This gallery shows some pictures of bad solderings - they should prevent you from making the same errors (feel free to add even more pictures here!)

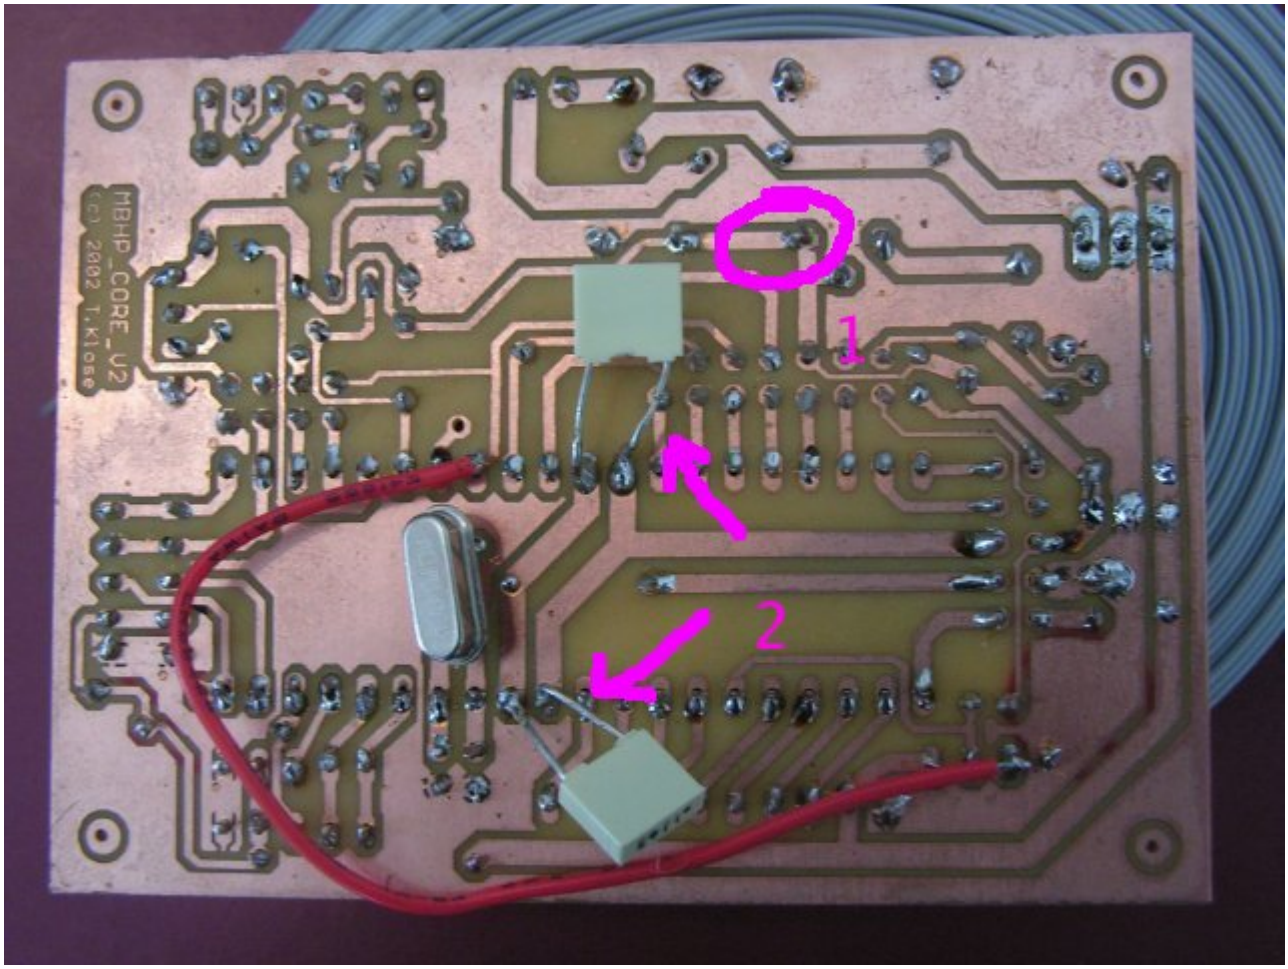
1: The core module has some badly soldered connections(loose), which could lead to failures. There are also missing solderings (e.g. 33pF cap below crystal). It makes sense to solder each pad again, the Soldering guide in the Wiki gives some useful tips
2: The legs of the caps should be cut, otherwise they can cause a short circuit which can damage the PIC!

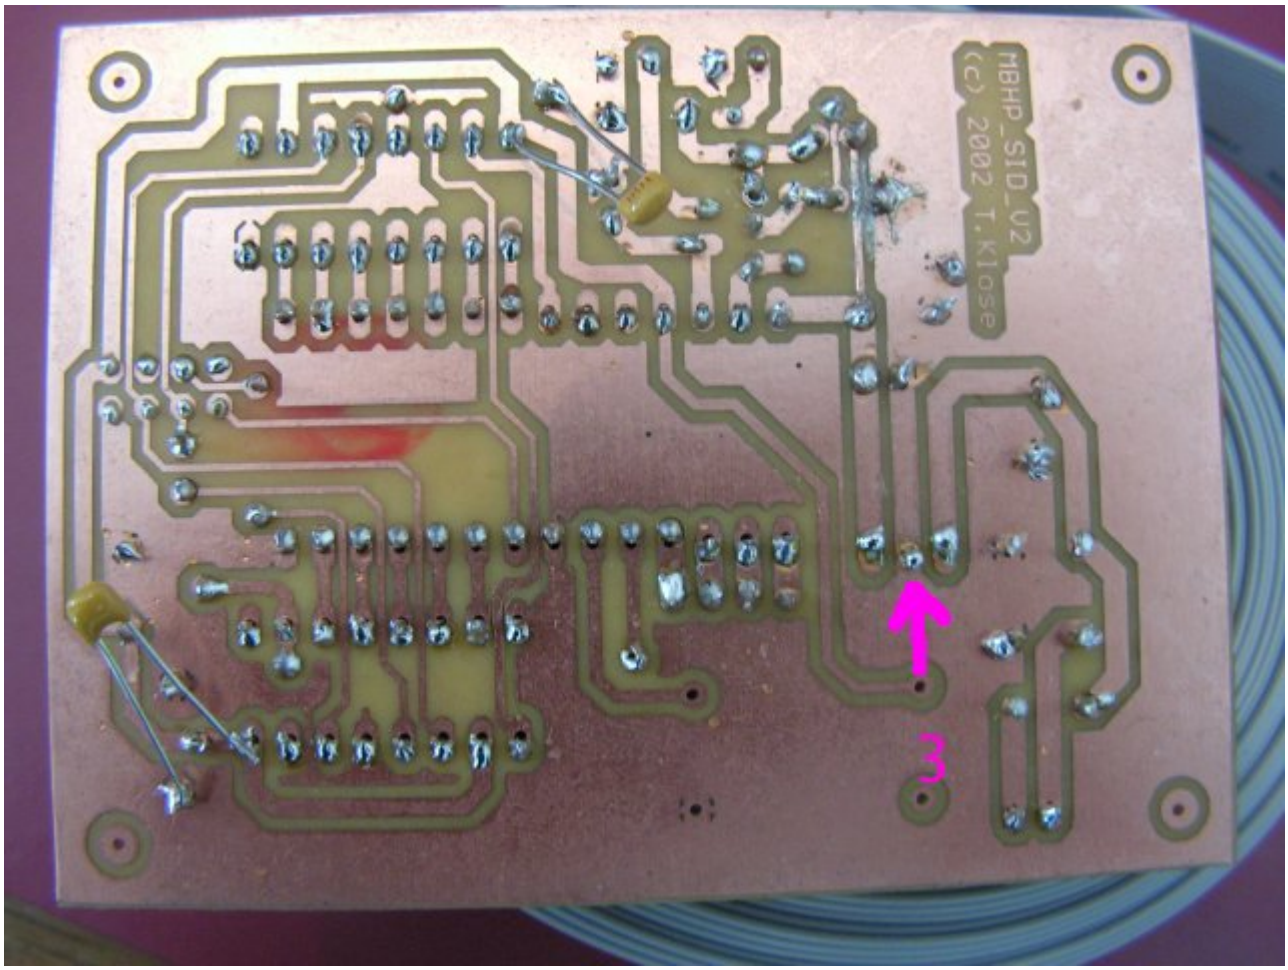
3: This seems to be a bad ground connection directly at the 78xx - it can lead to the wrong voltage. Here the same: just solder the pads again, it will help
And same as above: the long cap legs need to be cut, the danger of shorting out is too high!
